Prairie Pass Energy Storage CUP Feedback Comment Response			
Comment ID	Source / Agency	Feedback / Comment	Feedback Response
PLN01	Planner Review / Greg Barnes	Please provide a comprehensive height exhibit identifying the maximum height of all proposed structures and equipment, including but not limited to battery enclosures, transformers, poles, transmission structures, lightning systems, communication equipment, and any utility infrastructure. This is needed to demonstrate compliance with the maximum height requirements of the A-3 zone district or identify any requested deviations. Any structures exceeding the maximum height of 35 feet will need a variance for each structure.	The requested height exhibit has been added to the CUP application resubmittal package. A variance request will be submitted for the project's lightning protection masts which are expected to exceed the 35 foot height limit. Please refer to the updated IFP Plan Set Sheet C-400 on page 34 of Prairie Pass CUP Update Final for the preliminary locations of the lightning protection masts. Please refer to the attached Height Exhibit on page 38 of the Prairie Pass CUP Update Final for heights of proposed structures

1 CHAIN LINK FENCE DETAIL
C-500 SCALE: NTS

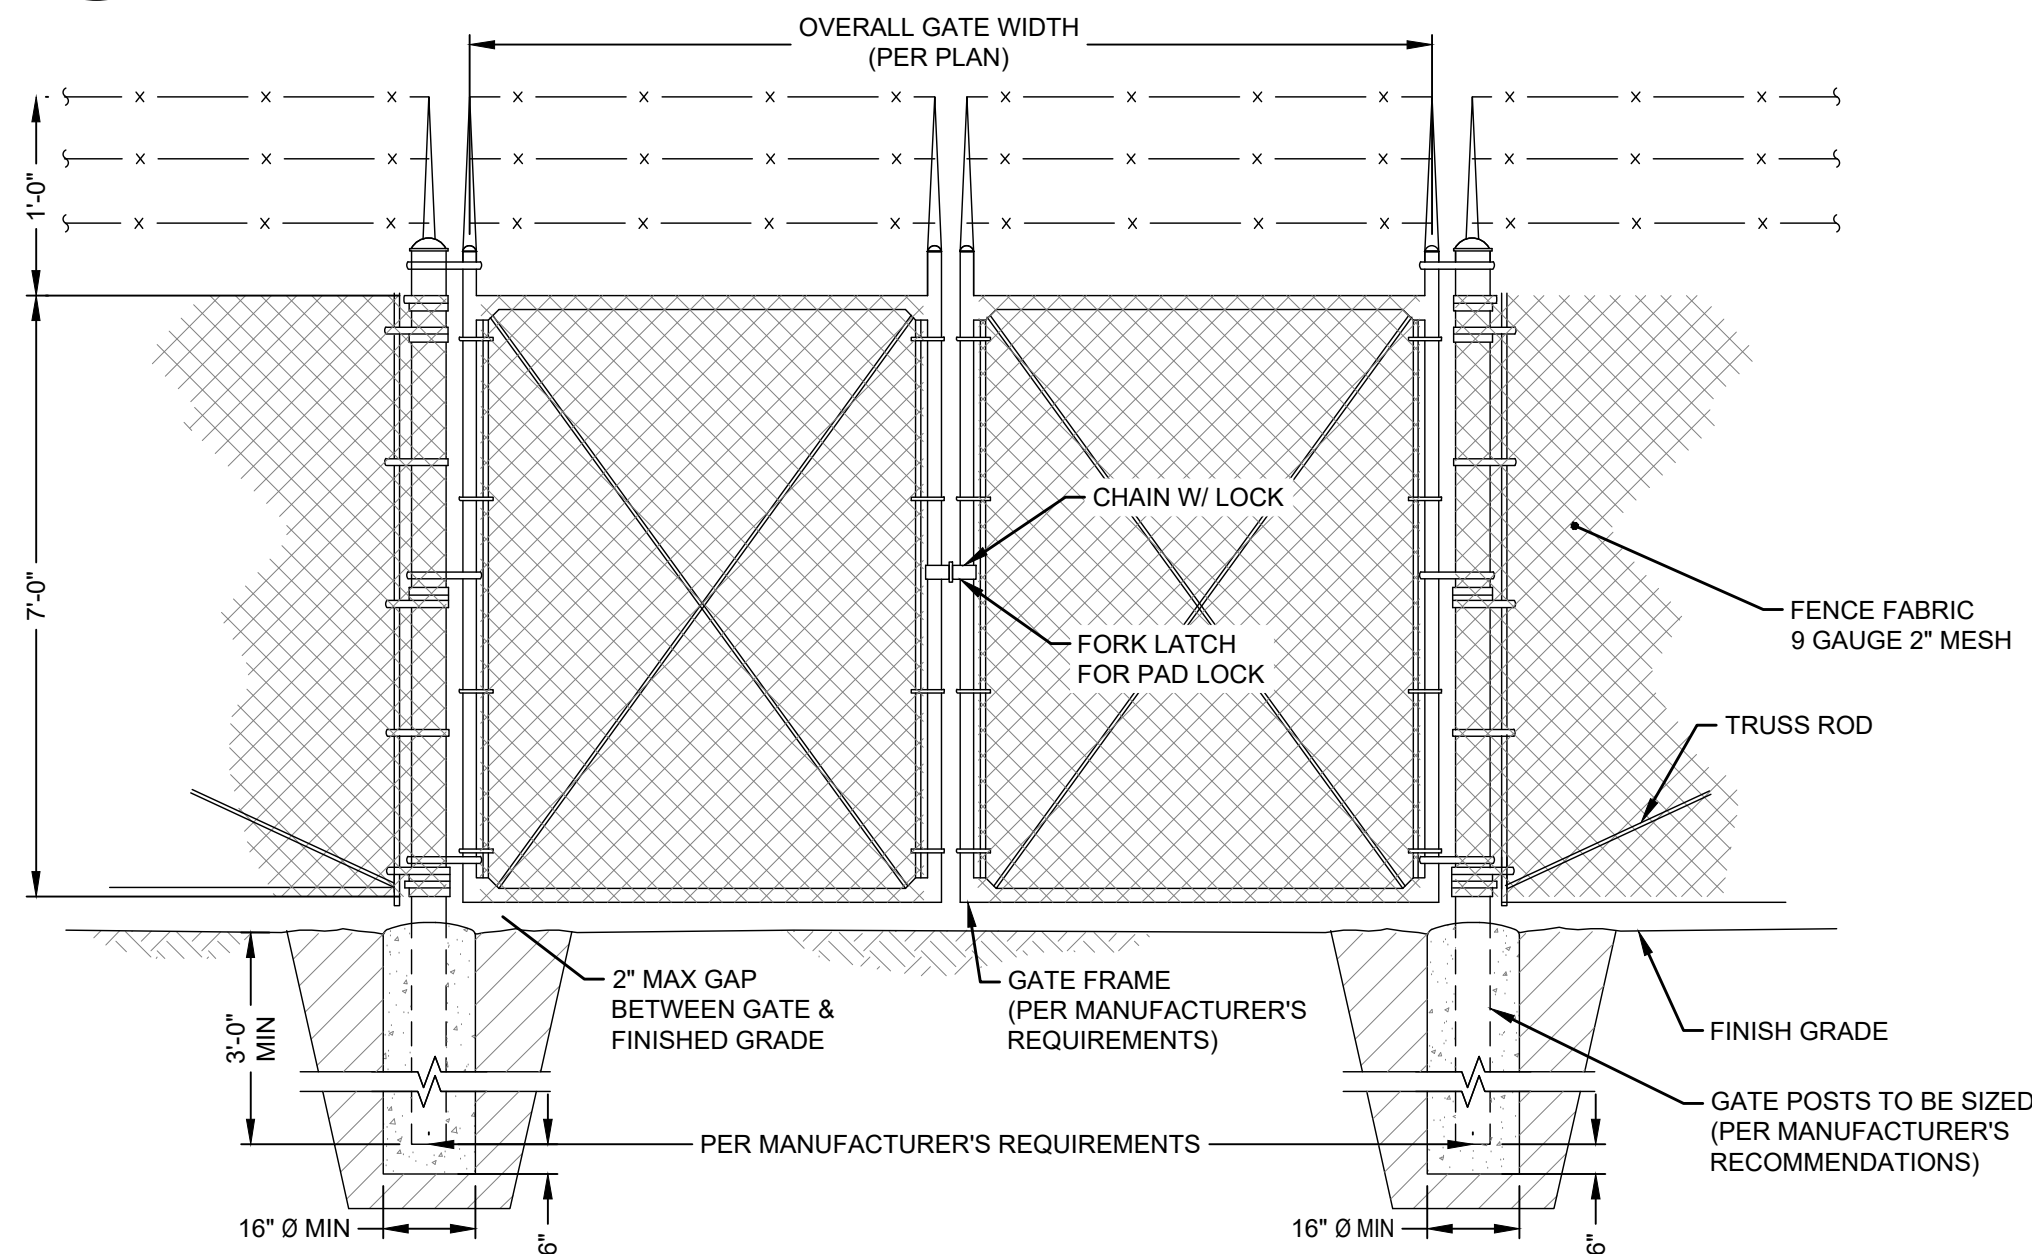
PLN02	Planner Review / Greg Barnes	Please provide detailed fencing plans, including fence height, materials, opacity, color, gate locations, and any proposed barbed wire or security features.	Fencing is assumed to be 7 ft of chain link with 1 ft of three strand barbed wire. Proposed fence heights meet both NFPA855 and Adams County standards. The site will have two large gated points of access off of Cavanaugh Rd, with multiple smaller man-gates around the fenceline. A Knox box for emergency access will be available at each gate. Please refer to the updated Prairie Pass IFP Plan Set Sheet C-401 on page 35 of Prairie Pass CUP Update Final for fence locations and plan details.
PLN03	Planner Review / Greg Barnes	Given the industrial appearance of the proposed use and the long-term reclamation obligations associated with battery energy storage infrastructure, staff recommends financial assurance acceptable to Adams County to guarantee decommissioning, removal, reclamation, and restoration of the site upon abandonment or cessation of operations. Please provide an estimate of these costs so that we can negotiate a bond amount.	Please see the attached 3rd party estimate on page 39 of Prairie Pass CUP Update Final for decommissioning, removal, reclamation, and restoration costs at project end of life. Note that this is an end of life estimate, so revisions are likely necessary depending on the timing of the financial assurance posting.
